SUBJECT: Zoning Application No. G-834, Potomac Garden Nursery, 12024
Darnestown Road, North Potomac, Potomac Subregion Master Plan

The following is Community-Based Planning's memorandum and comments on the above referenced zoning application and accompanying schematic development plan, the latest version of which was received on June 28, 2005. I would be obliged if you would include it in it's entirety in your report, either as text or as an attachment.

SUBJECT: Zoning Application G-834, Potomac Gardens

Re: Stormwater Management **CONCEPT** Request
for Potomac Gardens
Preliminary Plan #: NA
SM File #: 218151
Tract Size/Zone: 5.29 acres/RT-8
Total Concept Area: 4.29 acres
Watershed: Muddy Branch

A-300 SCALE: 1/4"=1'-0"
 FOR ONE
 ETON SQUARE

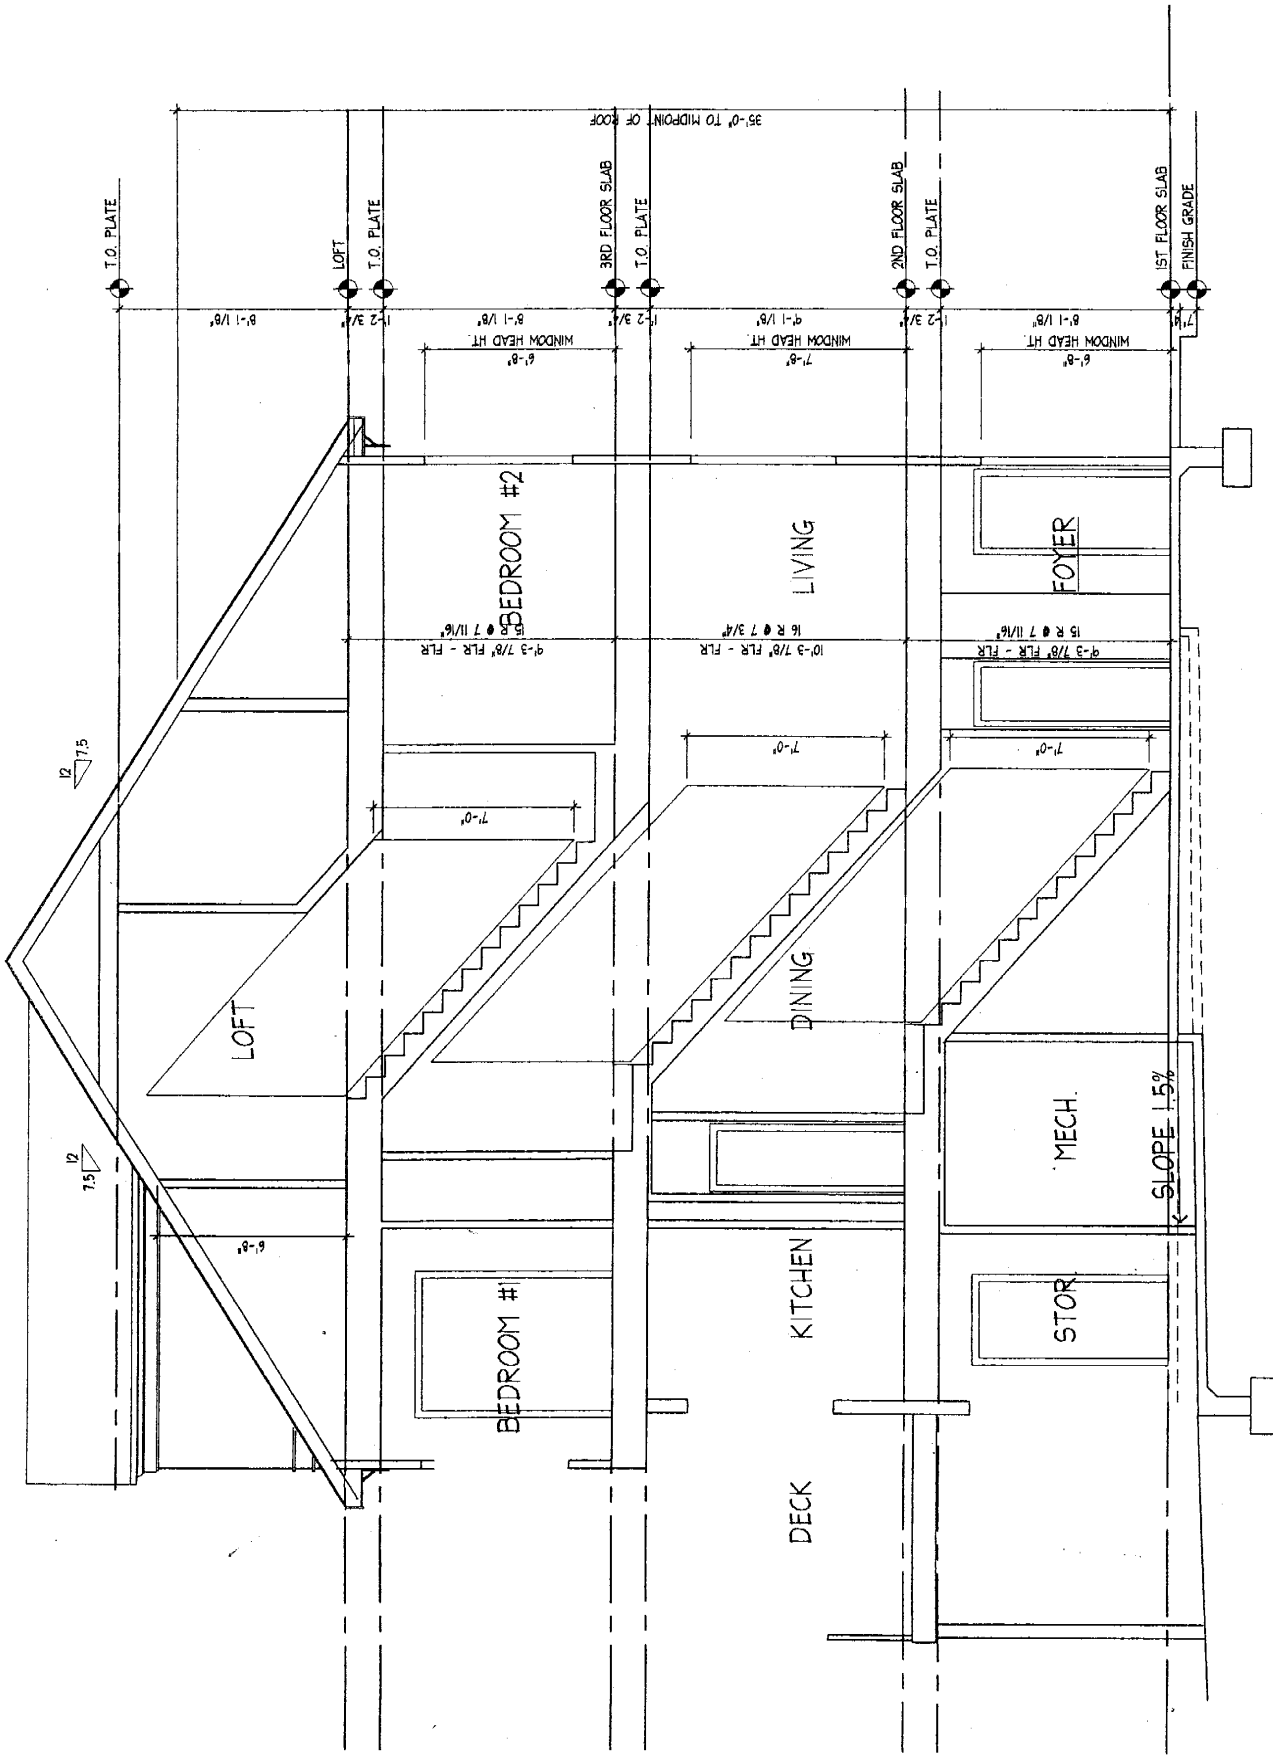
The Zoning Ordinance definition of the height of a building is the vertical distance measured from the level of approved street grade opposite the middle of the front of a building to the mean height level between eaves and ridge of a gable roof. The cross-sections accompanying the schematic plan assume 35 feet as the ridgeline height of existing single-family detached homes in the R-200/TDR Zone, (maximum building height 50 feet), and 44 feet from proposed ground level to the ridgeline of the proposed town homes. The 44-foot ridgeline would necessitate a structure above the maximum building height for the zone. This has been pointed out to Porten Homes who have agreed to substitute a building of 35 feet in height to the midpoint of the roof (See attached section). The following scaled measurements are based on a cross-section with a 42-foot ridgeline:

The difference in roofline elevations between the existing and proposed dwellings, (and relationship to distance), would be approximately as follows:

From Lot 4, Blackberry Drive to nearest unit – ridgeline elevation of town home would be 18 feet higher and 96 feet distant.

From Lot 5, Blackberry Drive to nearest unit – ridgeline elevation of town home would be 24 feet higher and 124 feet distant.

From Lot 10, Citrus Grove Road to nearest unit – ridgeline elevation of town home would be 13 feet higher and 117 feet distant.
